**INITIAL STATEMENT OF REASONS  
FOR PROPOSED BUILDING STANDARDS  
OF THE STATE FIRE MARSHAL  
REGARDING THE 2019 CALIFORNIA RESIDENTIAL CODE  
CALIFORNIA CODE OF REGULATIONS, TITLE 24, PART 2.5  
(SFM 02/19)**

### Example 1

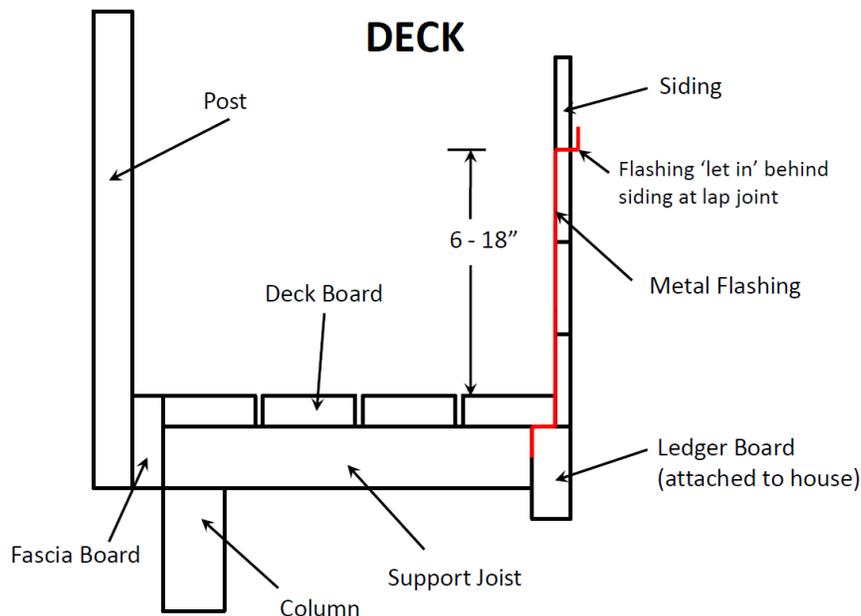
It has been shown that applying metal flashing to the intersection of the wall and the deck will protect the wall from flame spread along the deck, at a small additional cost.

Section 5.6.4 A minimum of 6 in. (150 mm) noncombustible vertical separation between a horizontal surface and siding shall be maintained.

The examples 1 and 2 are show for reference only on to how one may achieve compliance with the code proposal. The code was written as a generic regulation to leave it up to the designer, architect or owner to create a desirable look to meet the intent, which is to prevent the accumulation of debris at the base of the intersection of the exterior wall and deck surface.
